Contract No. T201106205.01
PAVEMENT & REHABILITATION, SOUTH I-V, 2011
Kent County

Enclosed is Addendum No. 3 for the referenced contract consisting of the following:

P.C.C. CURB TYPE I
N.T.S.

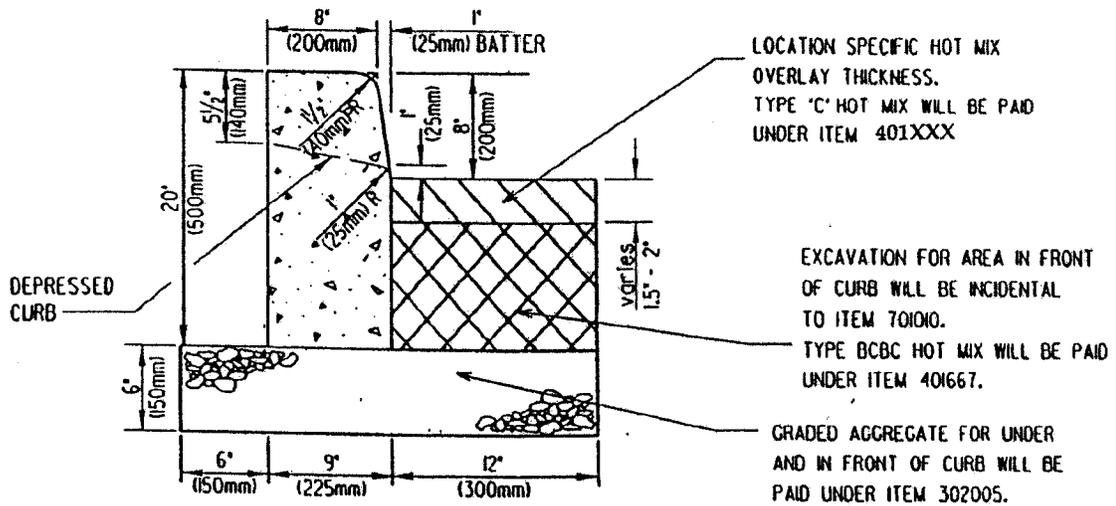
Location 1 - This item is for the removal of p.c.c. curb (per the traffic statement). However, the p.c.c. curb item 701010 is not in the location estimate. Item 701010 will be added per Addendum #3.
